SUBJECT: NuScale Power, LLC Response to NRC Request for Additional Information No. 317 (eRAI No. 9254) on the NuScale Design Certification Application

eRAI No.: 9254

NRC Question No.: 03.07.02-33

Figure 1: Plan View Dimensions of the Exterior Shear Walls

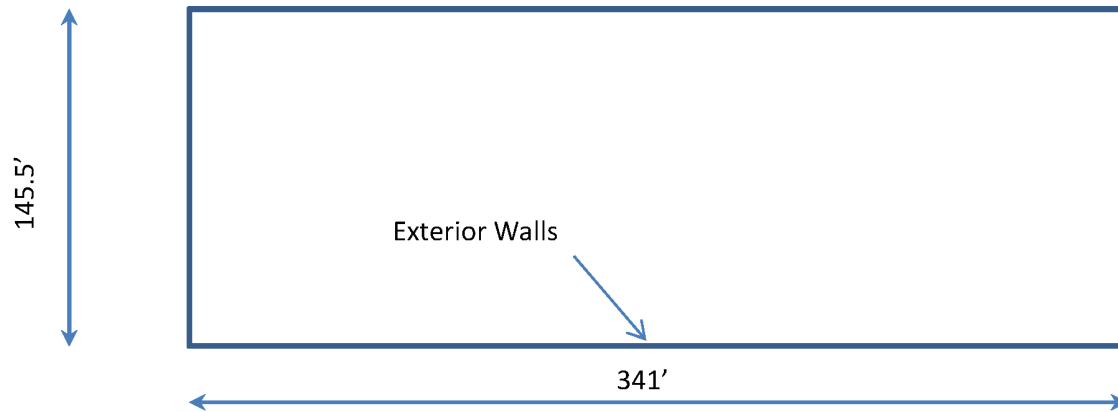
The staff reviewed the applicant's approach to addressing accidental torsion by increasing the horizontal element forces by 5% in lieu of increasing the eccentricity by 5%. The staff is unable to determine the validity of the applicant's approach that involves a uniform increase of horizontal element forces by 5% in contrast to the DSRS methodology that involves an increase of 5% torsional eccentricity on a floor level. DSRS 3.7.2, Acceptance Criteria II.11 specifies that, to account for accidental torsion, an additional eccentricity of plus or minus 5% of the maximum building dimension should be assumed for both horizontal directions and that the magnitude and location of the two eccentricities are determined separately for each floor elevation. The staff also notes that similar guidance on accounting for accidental torsion is available in industry standards; e.g., ASCE 4-16 specifies that the effect of accidental torsion be calculated at each floor level by static analysis assuming a torsional moment equal to the product of the story shear and 5% of the plan dimension perpendicular to the direction of motion of the structure at that level.

The staff finds that the applicant has not demonstrated that an eccentricity of 5% of the building

dimension is equivalent to a 5% increase in the elemental horizontal forces. Therefore, the applicant is requested to provide additional information that provides the requested technical justification to demonstrate the equivalency to the DSRS methodology or conservatism in the method used by the applicant. Compliance with the DSRS is not a requirement; however, the applicant should identify differences between the analytical methods used for its design and the DSRS acceptance criteria and evaluate the technical acceptability of its methods. The applicant may choose to use a smaller model to illustrate the comparison of the results from the two approaches.

Shear stresses in the exterior walls (plan view shown in Figure 1) due to both direct base shear and accidental torsion are calculated. Comparing the difference between them will show the significance of accidental torsion in the seismic demands.

Direct base shear creates in-plane shear on the 5 foot thick exterior walls that are parallel to the base shear. Due to the rigid diaphragms in the reactor building, under direct shear, all exterior walls will experience the same shear stress, to satisfy deformation compatibility.

As shown by these calculations, the effect of accidental torsion is 5% of the effect of direct base shear. This, in turn, indicates that, to equivalently account for accidental torsion effects, seismic demands can be increased by 5%.
